## SUCCESSOR AGENCY TO THE INDUSTRY URBAN-DEVELOPMENT AGENCY

- 5.1 Approval of Change Order No. 5 to Sukut Construction, in the amount of \$948,894.48 for changed conditions, storm drain and grading revisions, geotechnical recommendations, various items of extra grading bid quantity adjustment, and diesel fuel adjustment credit in conjunction with the Industry Business Center Mass Grading, Contract No. IBC-0380, as identified in Line Item No. 271 of the Recognized Obligation Payment Schedule.

**MEMORANDUM**

**SUBJECT:** Change Order No. 5 – Plan Revisions, Bid Quantity Adjustments and Other Items of Extra Work (IBC-0380)

**DROP JUNCTION STRUCTURE**  
SCALE: 1/4" = 1'-0"

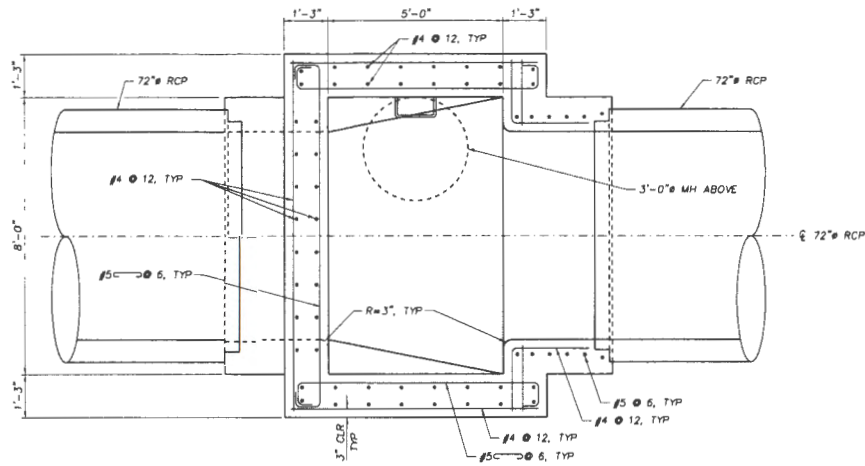
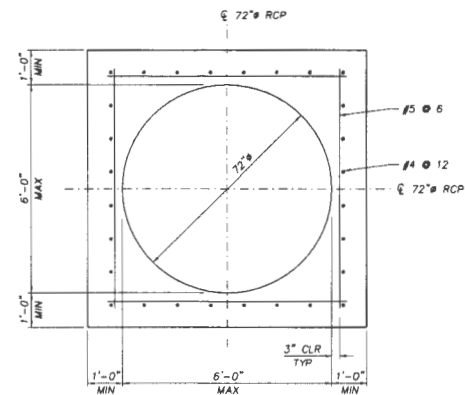
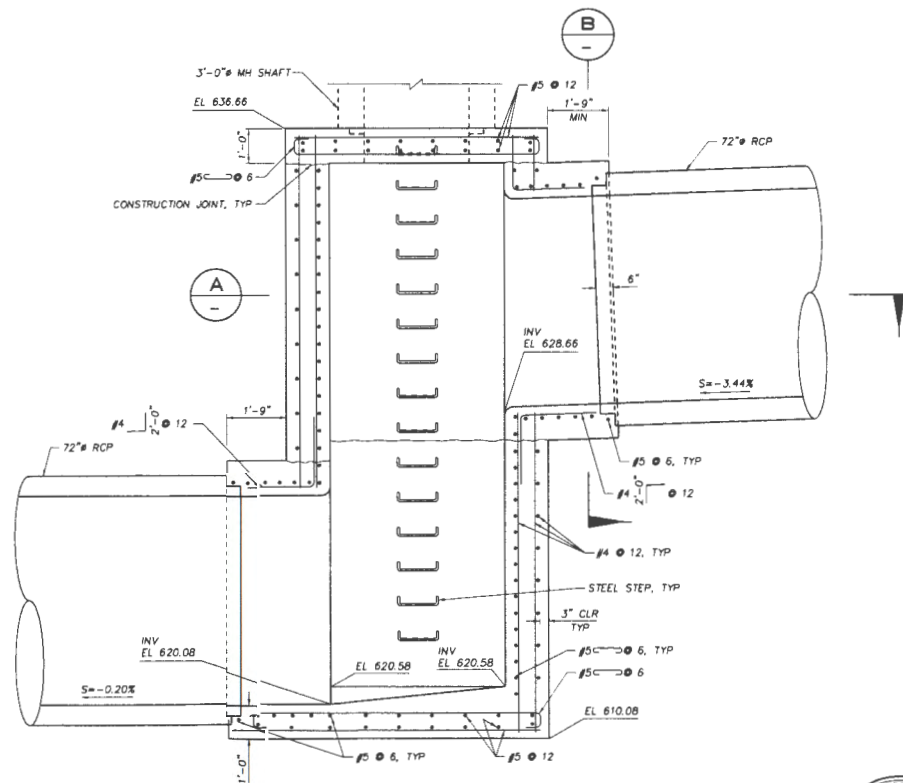
plans also added a drop structure (see attached detail), this work was performed on a time and material basis with costs totaling \$74,887.59.

This change order request includes all added labor, equipment, and material costs associated with constructing the Drop Structure for the 72" storm drain.
